260 N. Center Street, Front Elevation (East)

Three appealed items shown in red, marked on the City-approved drawing (A1 / Right Angle Drafting, Sheet 8. Field measurements highlighted in yellow.

FRONT ELEVATION
(EAST)

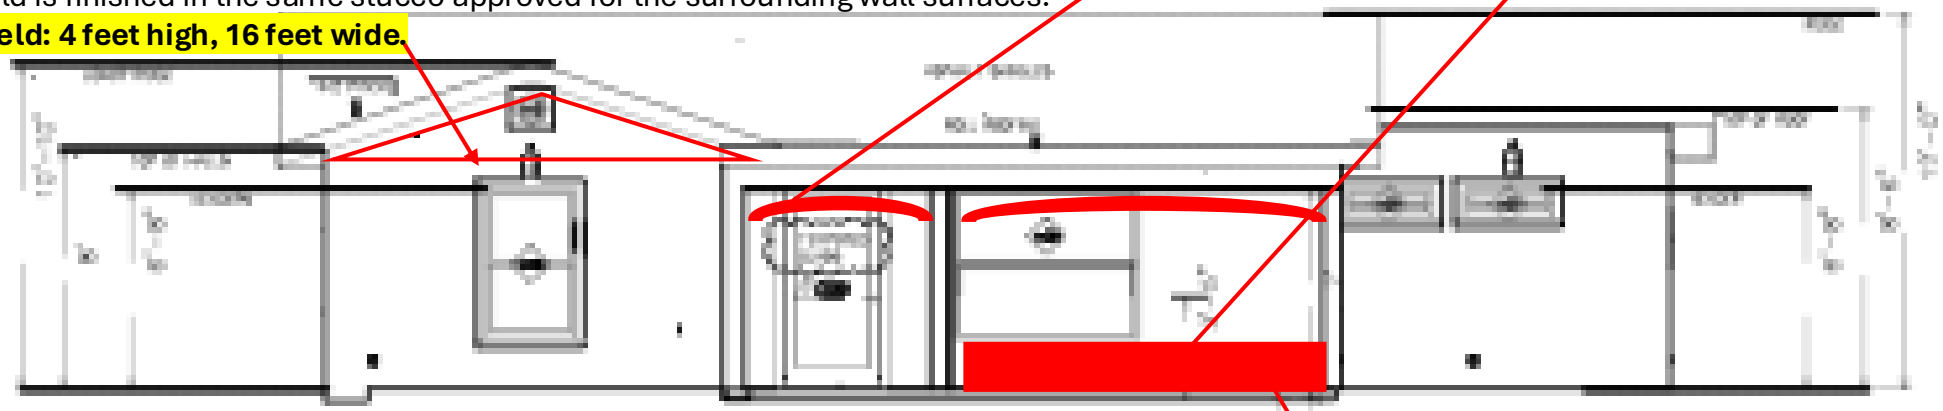
ITEM 1. Gable field, durable stucco replacement.
Red indicates the gable field where the deteriorated wood elements were located. Staff confirmed on site in June 2025 that this material was damaged beyond repair. The approved Certificate of Appropriateness permits replacement in a similar, more durable material, and the Historic Preservation Officer confirmed in writing on June 10, 2025 that staff's interpretation of in-kind replacement allows other, sometimes more durable, materials. The gable field is finished in the same stucco approved for the surrounding wall surfaces.
Gable field: 4 feet high, 16 feet wide.

ITEM 3. Softly rounded edges beneath the porch beam.
Door and window opening: radius of approximately 6 inches high and 10 inches wide. The rounded edges echo the original interior arches documented in the independent appraisal photographs, and arched openings are established across contributing properties in the district. No historic material was removed to create them. They are a finish detail on new porch framing.

ITEM 2. Low pony wall, fully reversible.
34 inches tall and 13 feet 6 inches long. Fixed to the new porch posts, not to the original 1945 structure. It can be removed without any loss of historic material or damage to historic fabric. The August 10, 2026 denial marks Standard 10 as consistent.
